**BEFORE:** ST. ALBERT SUBDIVISION AND DEVELOPMENT APPEAL BOARD

**FILE NUMBER:** DP073108/SDAB FILE 3011.65

**DOCUMENT:** WRITTEN SUBMISSIONS and EXHIBITS OF GARY ACHESON and SARASOTA HOMES

**Hearing: April 15, 2026**

**1 BASEMENT PLAN**  
SCALE: 1/8" = 1'-0"

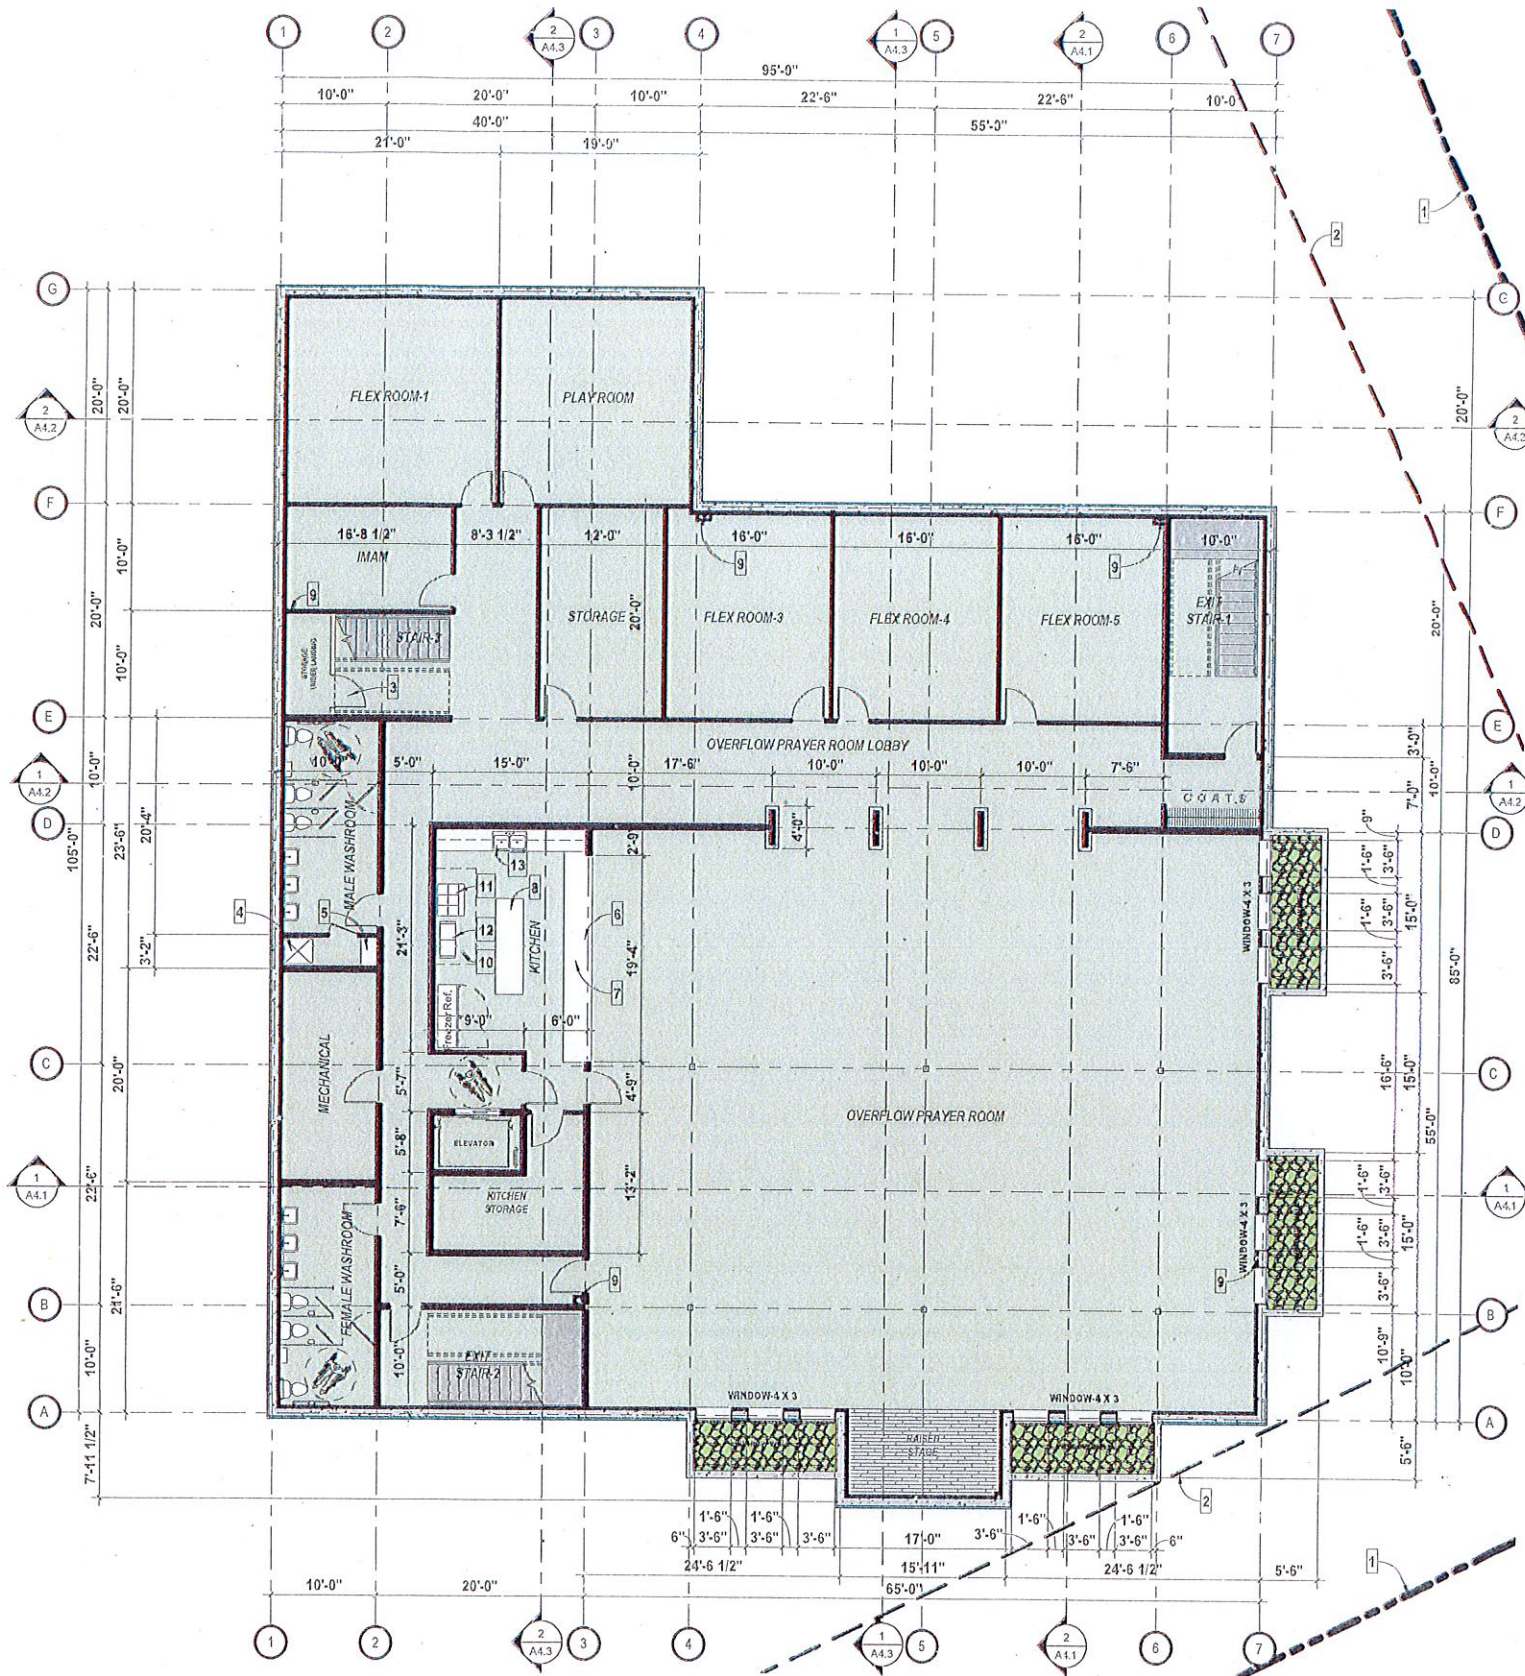
13. However, architectural drawing A2.1 **[Tab 3]** shows the Basement Plan designed with an “Overflow Prayer Room” of a similar dimension as the area of the “Men’s Prayer” area on the main floor. Adjacent to the basement’s Overflow Prayer Room is a lobby labelled as prayer overflow with similar dimensions to the prayer overflow lobby on the main floor. The Development Plan assumes a prayer space per worshipper of approximately 13.63 sq ft for the main floor Men’s Prayer area and 16.67 sq ft per worshipper for the main floor lobby prayer space. Applying these numbers to the comparable overflow spaces in the basement, the Overflow Prayer Room will accommodate an additional 262 occupants and the lobby overflow prayer space will accommodate an additional 45, for a total of 307 additional occupants in the basement worship spaces, which were not taken into account in the TIA. This brings the total worshipping occupants for the New Mosque to 837. As a reference see the Occupancy Spreadsheet attached as **Tab 4**.

**1 BASEMENT-PRAYER ROOM LAYOUT**  
 SCALE: 3/32" = 1'-0"

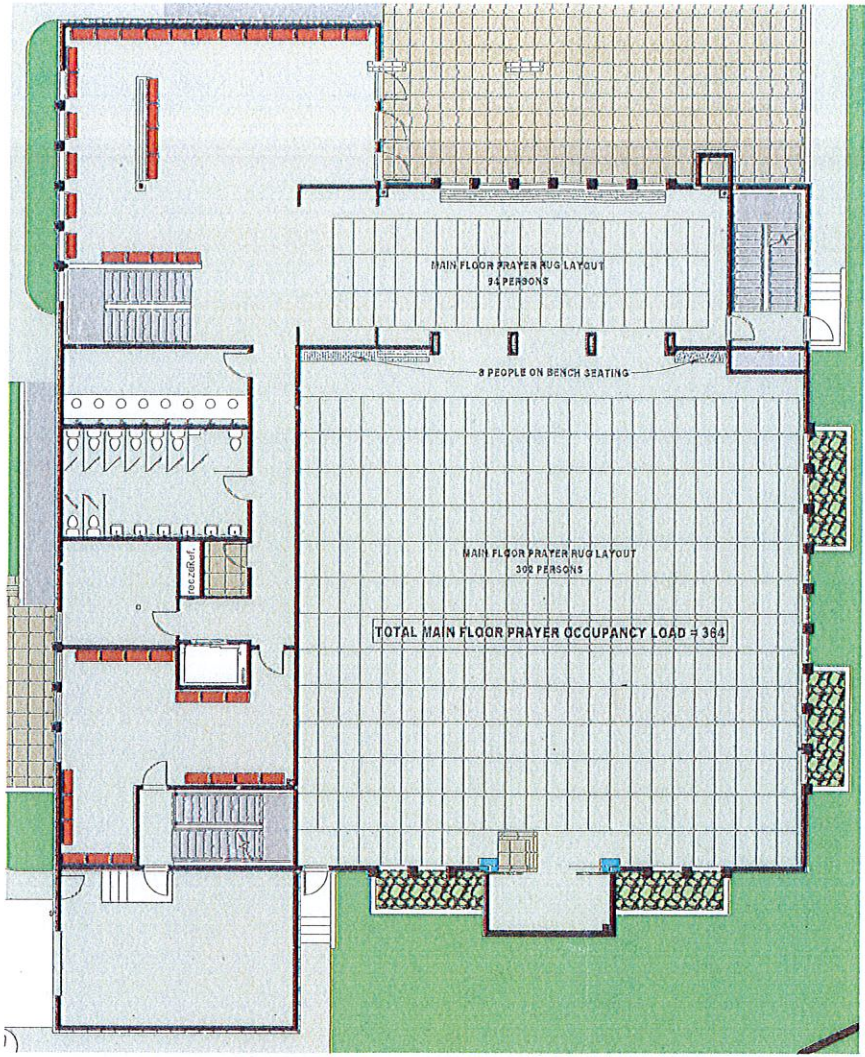
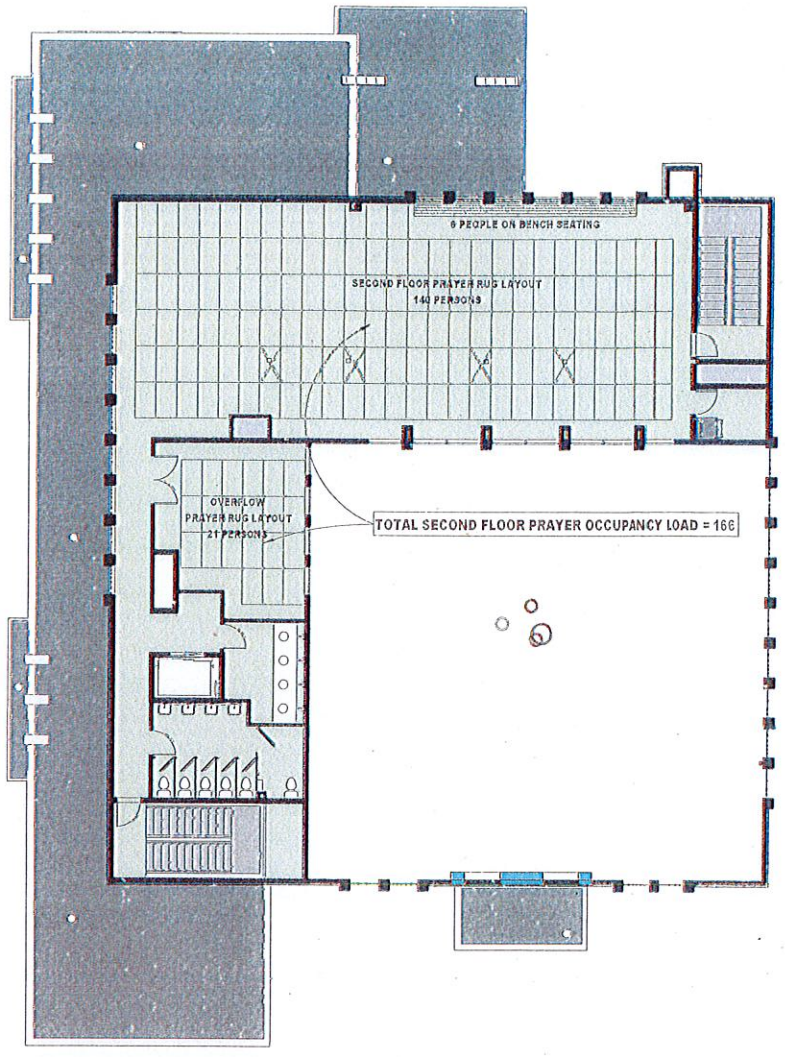
11. The proposed development has understated the occupant capacity of the New Mosque for the purposes of calculating parking requirements.
12. The development plan prepared by Hartwig Architecture in support of the New Mosque (the “**Development Plan**”) shows a “Men’s Prayer” area on the main floor, as well as a secondary lobby designated for prayer overflow.<sup>4</sup> Together these two areas are estimated by the Applicant to accommodate only 364 occupants. The second floor “Women’s Prayer” room and “Learning Centre,” which is designated for prayer overflow, is estimated to accommodate 166 additional occupants. This gives

16. Even a worship capacity of 837 - 942 individuals is still an underestimate because the standard average space for a mosque worshipper is significantly less than the 13.63 – 16.67 sq ft estimated by the Development Plan. In an academic paper on Islamic Design Standards for public buildings, Ahmed Mokhtar, a professor with a PhD in architecture and a specialist in Islamic design standards, notes a minimum
